memorandum

TO Chris Simpson FROM Parviz Namjou
DATE 17 February 2015
RE QUESTIONS REGARDING THE THREE KINGS DEVELOPMENT

The following memo addresses the matters raised following your review of the groundwater modelling results submitted on 23 December 2015 and our subsequent meeting on 28 January 2015. The main matters are summarized below:

Figure 1: Effects of the Fill Placement on Predicted Groundwater Level Rise after 100y Rainfall Event

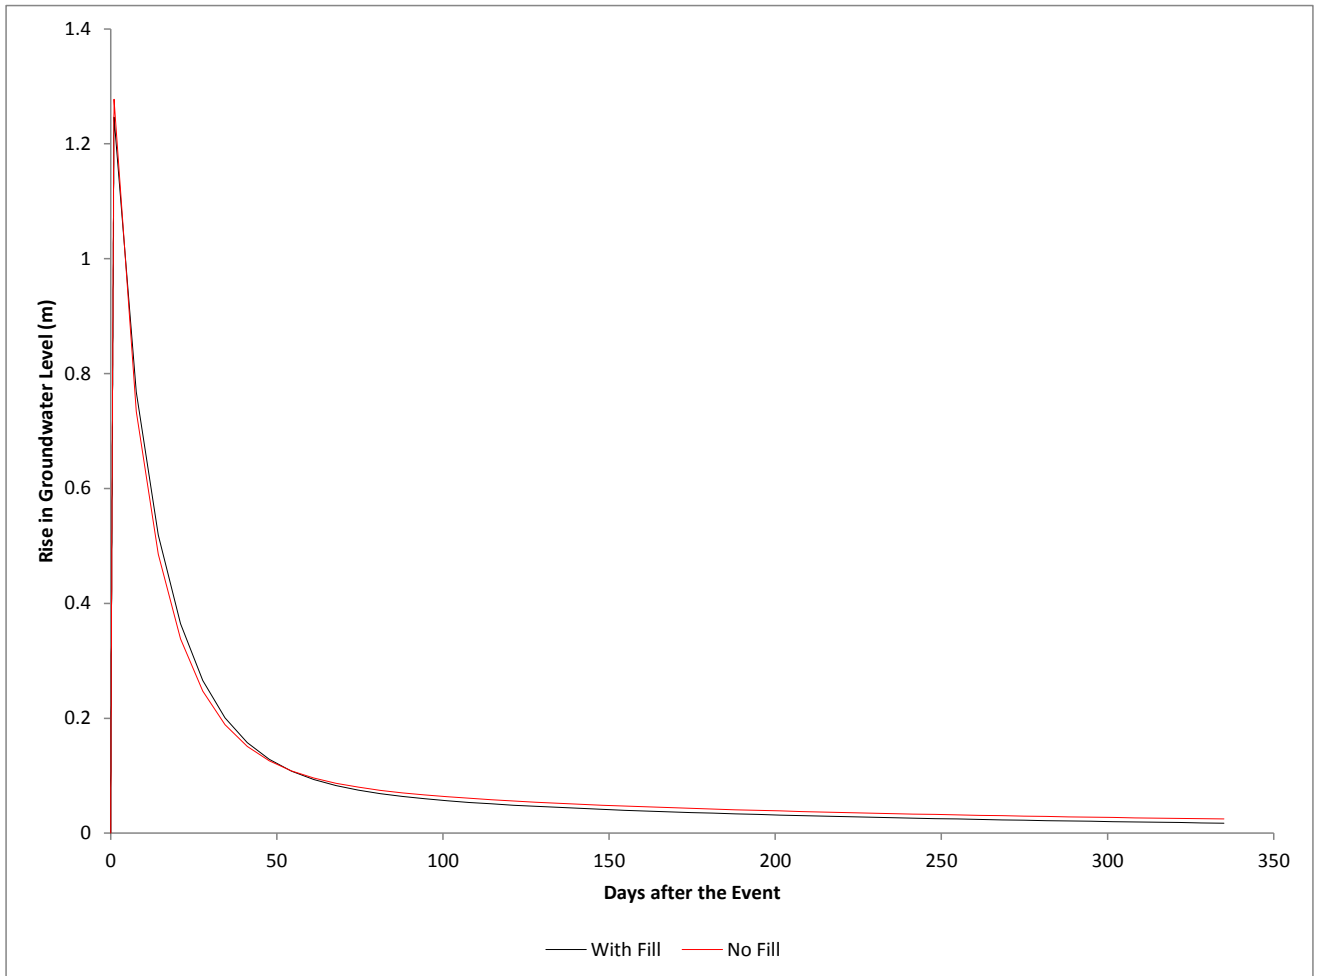
The following two scenarios were run to assess the effects of Fill placement on the long-term groundwater levels and groundwater level rise during a 100y rainfall event.

- 2) Additional groundwater modelling analysis was carried out to assess the effects of Fill placement on the predicted water level rise after a 100y rainfall event. In one scenario the Fill was placed over the development area (from the surface down to RL40m) and in the other scenario no Fill was assigned. The permeability of the Fill for this analysis ranges between 1×10^{-7} m/s and 2×10^{-5} m/s. However the model is not sensitive to variations in permeability of the Fill. The infiltration rates for the event (PDP 2015) are assumed to be the same for both scenarios.

The predicted water level rise in the cone for the above two scenarios for the centre of the crater is shown in Figure 1. The results indicate no significant changes (<2%) in the predicted water level rise.

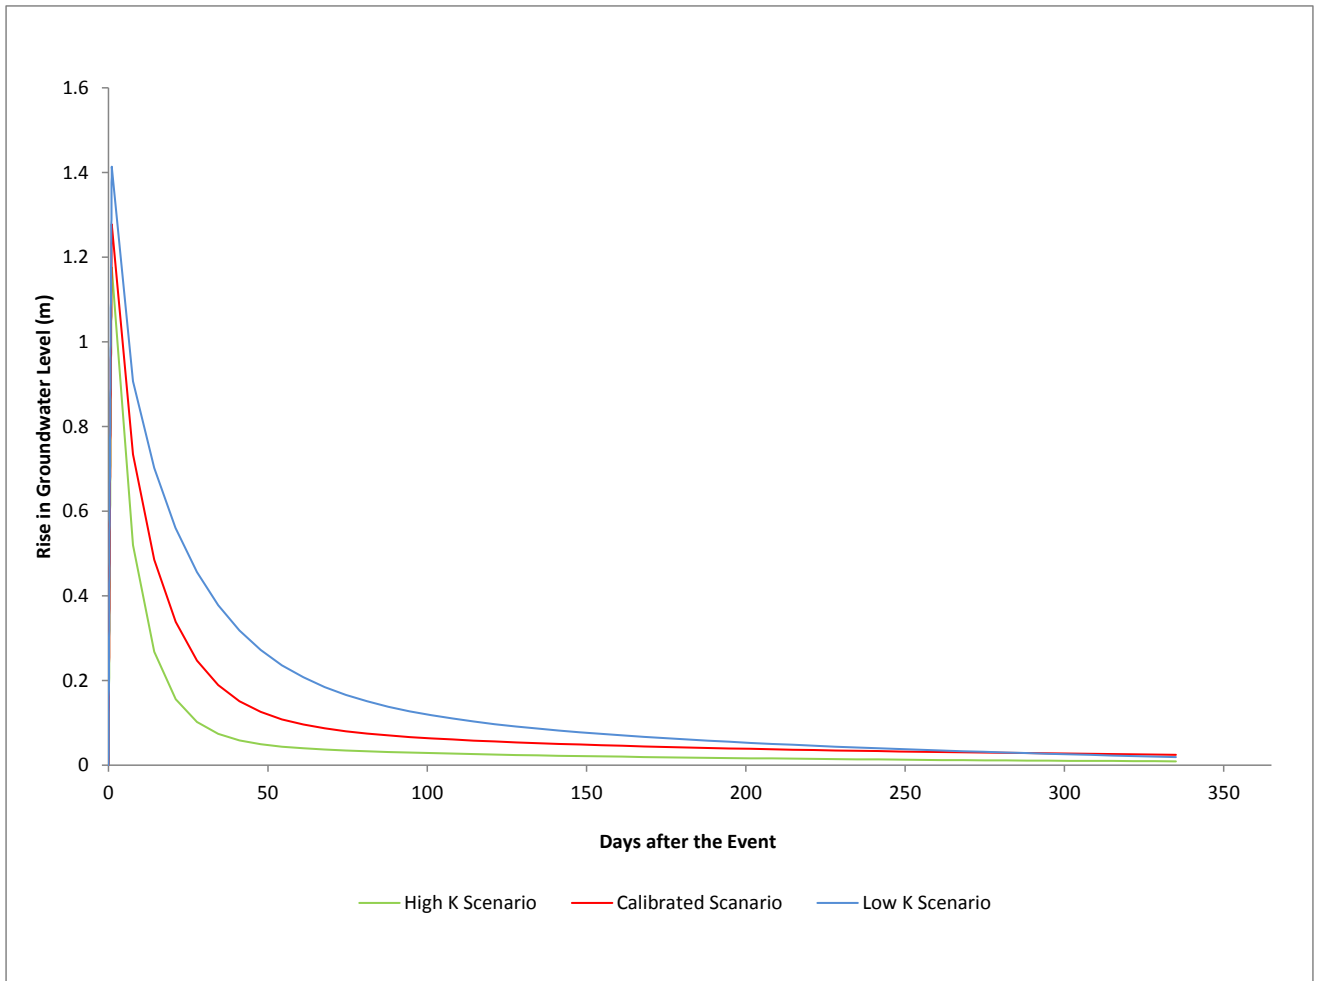
However, as a sensitivity check effects of 50% reduction ($k=1 \times 10^{-4}$ m/s) and 100% increase in the basalt/scoria hydraulic conductivity ($k=4 \times 10^{-4}$ m/s) was assessed and the results are shown in Figure 2. The reduction in permeability by 50% doubles the calibration error (the difference between measured and calculated heads increases by about 0.5m). For this scenario the predicted groundwater level rise as a result of a 100y rainfall event is 1.44m

(0.2m more than predicted using the calibrated model). The 100% increase in permeability reduces the magnitude of the groundwater level rise by about 0.1m (Figure 2).

Figure 3: Historical Groundwater Levels Hydrographs, top: Meola Rd monitoring bore, bottom: Chamberlain Park bore (note the groundwater levels at in mRL, source: Auckland Council monitoring data)

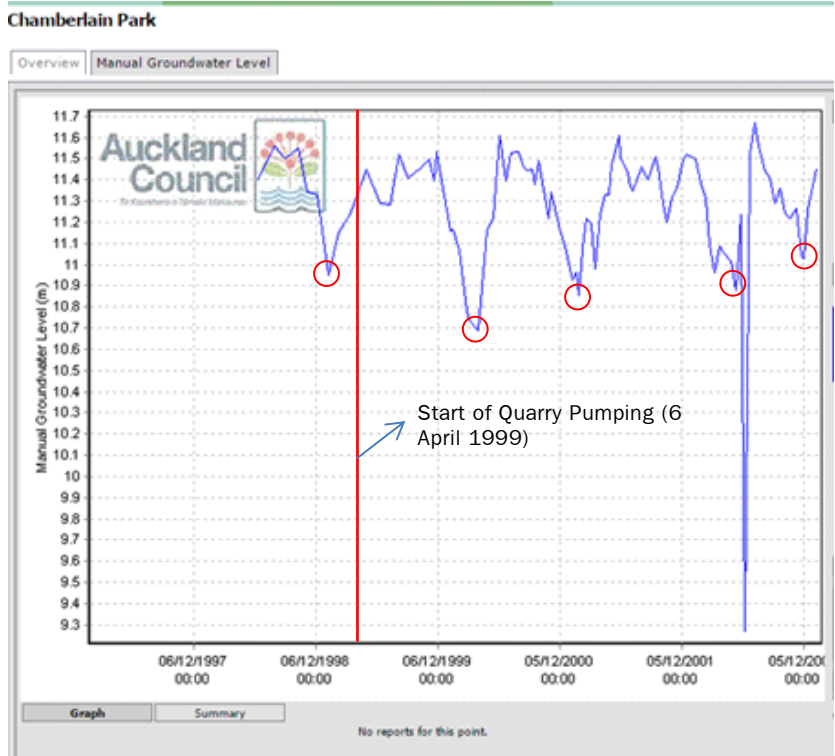
The historical groundwater level hydrographs for two monitoring bores in the basalt at Meola Rd and Chamberlain Park are shown in Figure 3. These bore are located in the lower Western Springs catchment areas and are most suitable for this assessment. The low annual groundwater levels in dry conditions before and after the dewatering (6 April 1999) are shown on the hydrographs. The results indicate that the quarry pumping and subsequent reduction of about 2500m³/d throughflow in the Meola aquifer has had no significant effect on the groundwater levels in lower catchment areas.

Figure 4a: Extent of land development in the Meola Surface Water Catchment in 1996, 3 years before dewatering.

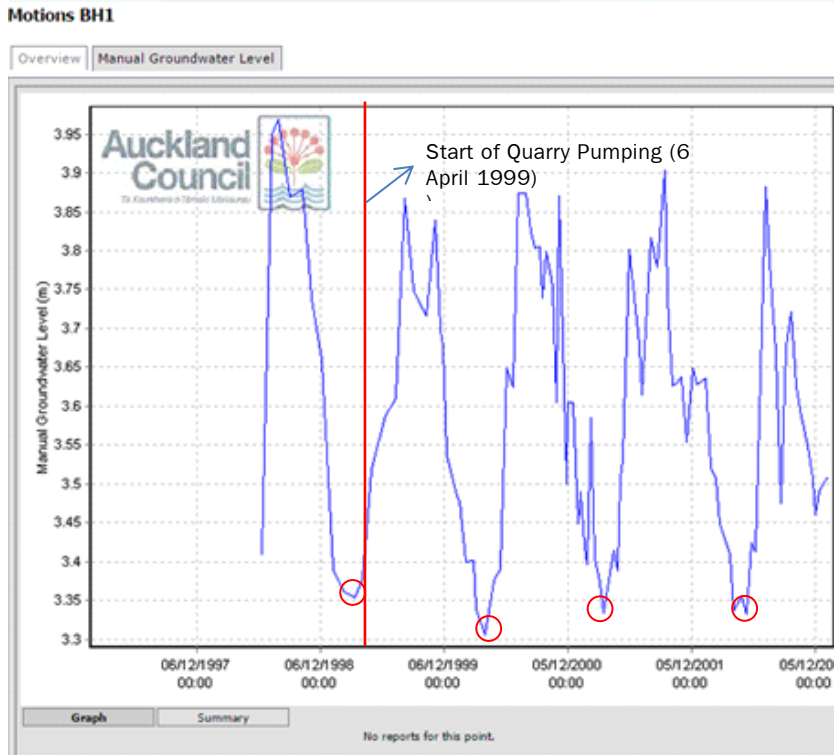
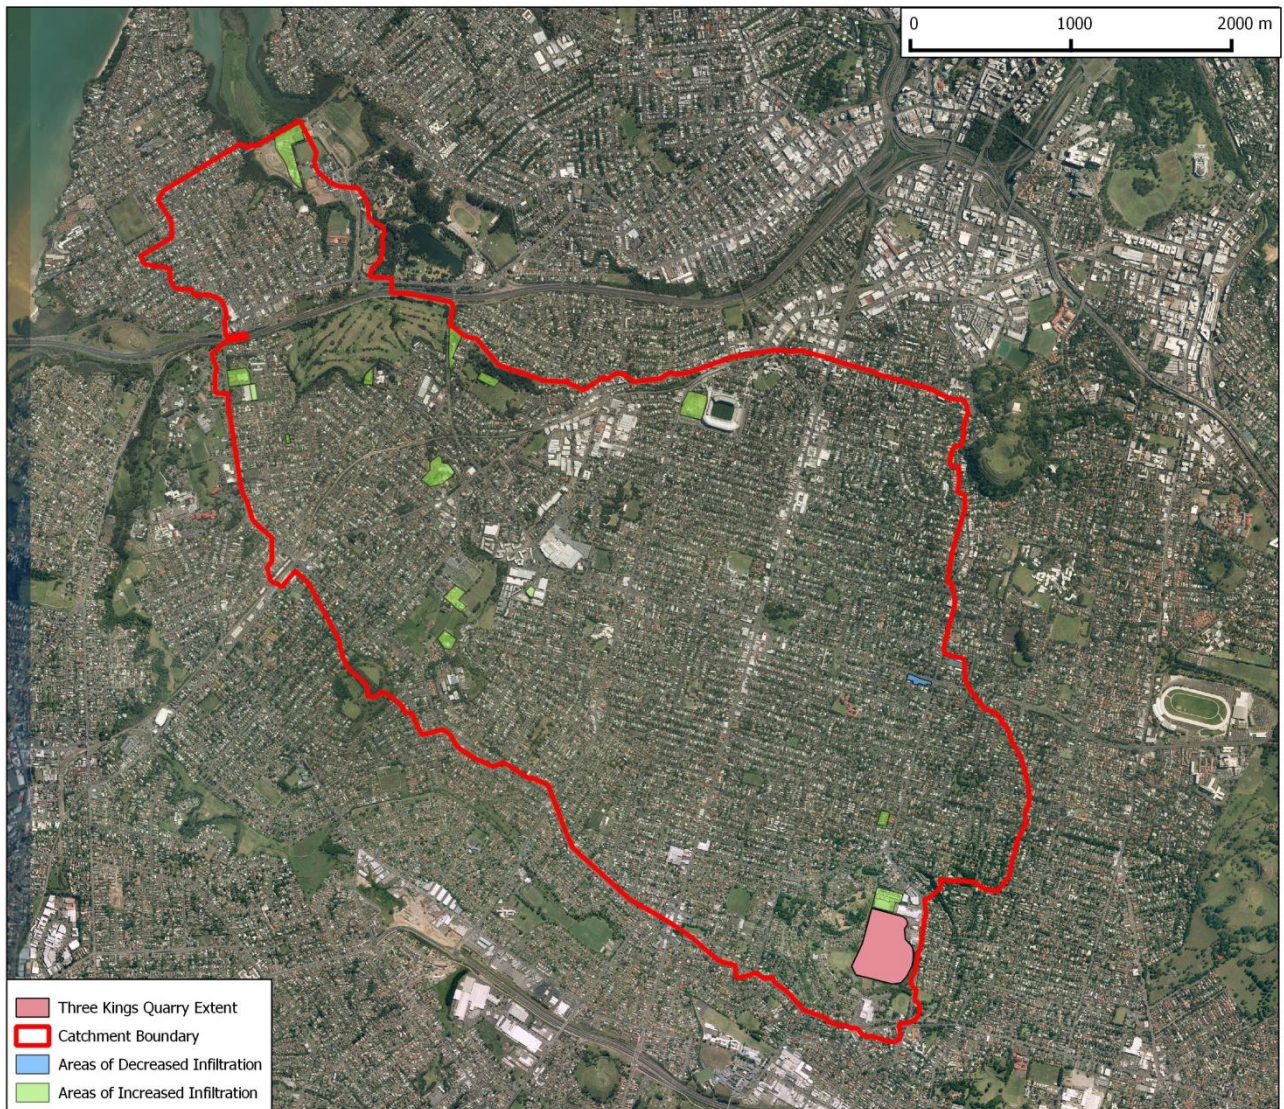
Since the onset of dewatering, the extent of imperviousness within the catchment has changed very little. Figures 4a and 4b show the Meola Catchment before and after the quarry dewatering. The catchment was almost completely developed prior to the onset of dewatering; therefore the only changes in the impervious area have been minor. Based on the historical records (Auckland GIS system), 14.8ha of the catchment was developed since 1999 while 0.55ha of developed area has been transferred to open space (parks) during this time. With a total catchment area of 1510.2ha, the above increase in imperviousness represents less than a 1% change. Such a small increase in imperviousness (potential increase in soakage holes and infiltration rate) is unlikely to have any effect on the groundwater levels.

Figure 5: Relationship between lava flows east of the quarry pit

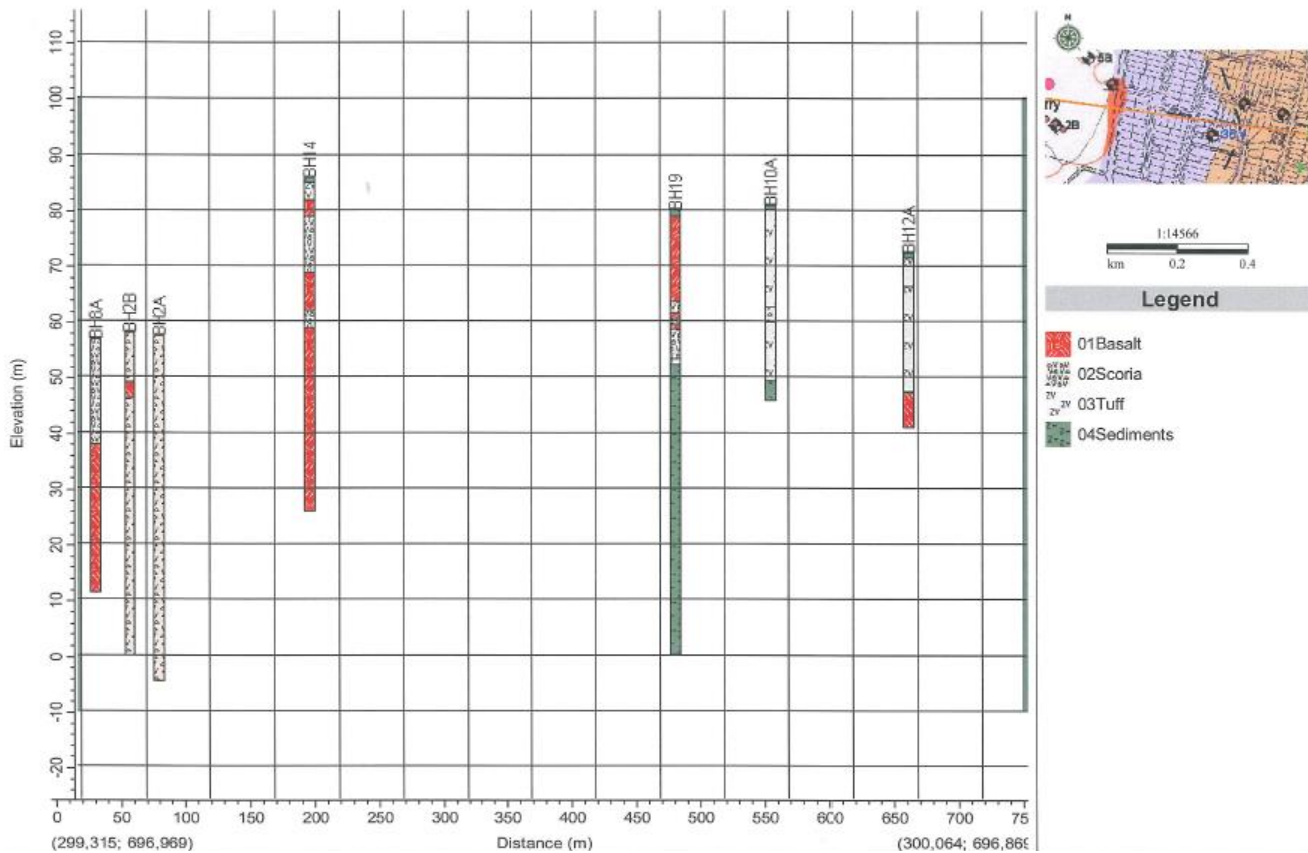
It was suggested that the basalt of the Greater Onehunga Aquifer found in BH12 is potentially connected to the Three Kings Complex through a breach of the tuff ring along the south-eastern boundary of the crater. This suggestion is based on the proximity of basalt in boreholes 12A and 12B outside the cone to the east with that seen in boreholes 19, 11A and 11B within the cone. This would imply that the crater aquifer extends in this direction, and any associated groundwater flow will be influenced by changes to the quarry workings. As investigated in PDP (2008) this postulation is not supported by the available lithological information (Figure 5) which suggests that the tuff ring is likely to be continuous in this area.

- Boreholes 10A and 10B which lie between borehole group 19, 11A, and 11B, and borehole group 12A and 12B show no basalt (Figure 5), but instead tuff sitting directly on non-extrusive sediments (Tauranga Group). This indicates a lower permeability tuff bund between the two basalt flows;

Figure 6B: Contours of the area showing the spring

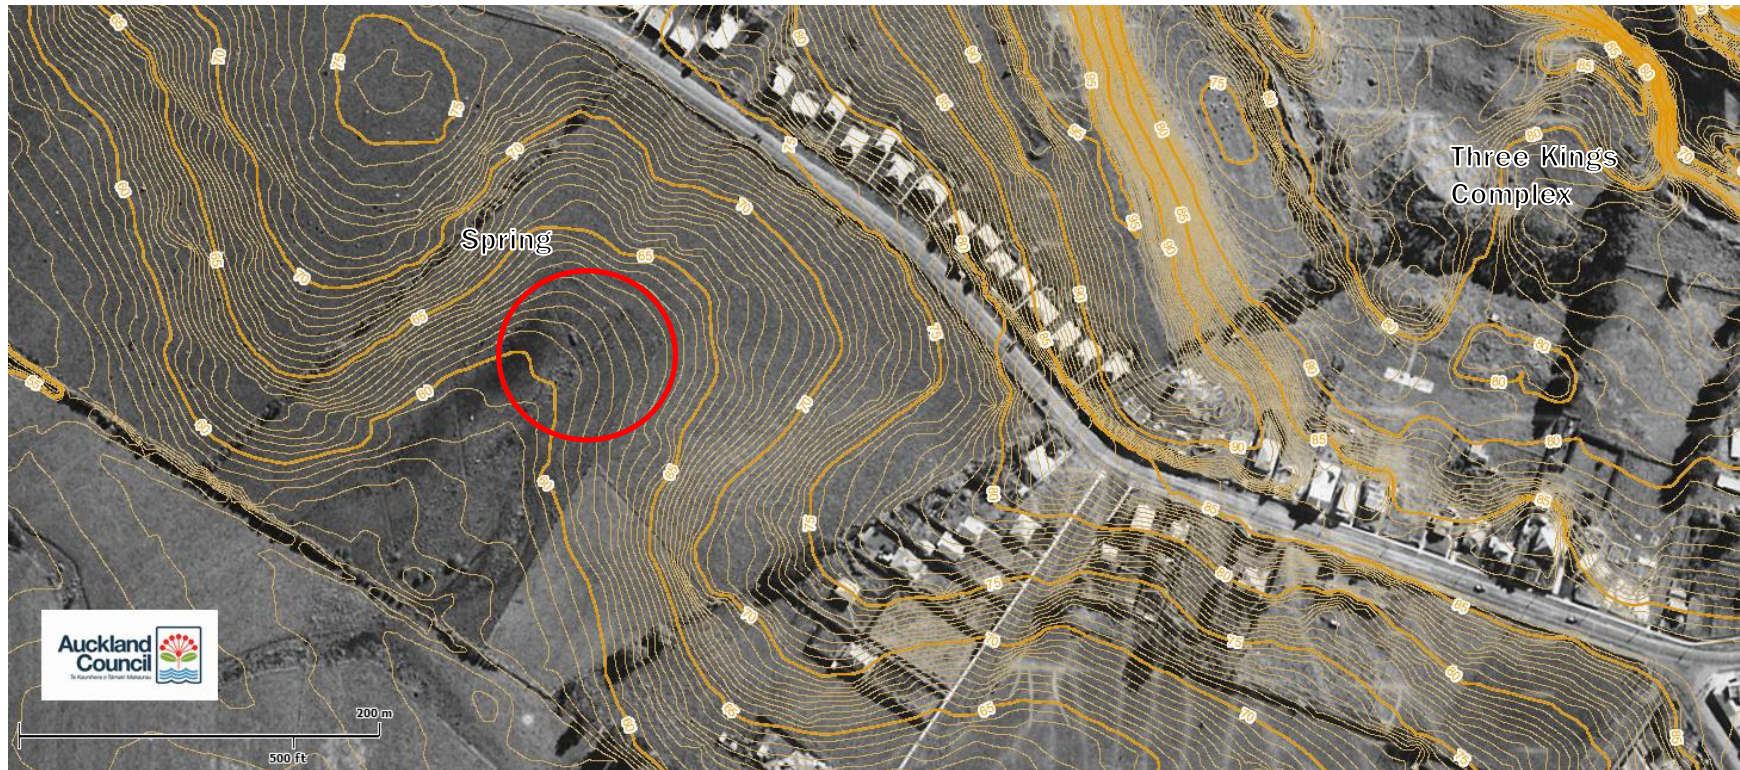
A spring is noted in an historic aerial photo taken in 1940 (Figures 6A and 6B) at an elevation of about RL60m and it is suggested that it may represent a potential groundwater flowpath from the crater towards the southeast. However, Bore BH22 (Appendix A.1) drilled approximately 50m from the spring’s original location shows that the basalt is

discontinuous between the Three Kings Complex and basalt located to the southwest. This indicates that the original lava flow cannot have exited the cone in this direction, and thus the basalt aquifer cannot extend in this direction.

The location of the spring is close to the location of a Waitemata Group paleovalley along Oakley Creek. This suggests this spring may have been sourced from a separate groundwater system within ECBF (or overlying perched layers within the tuff).
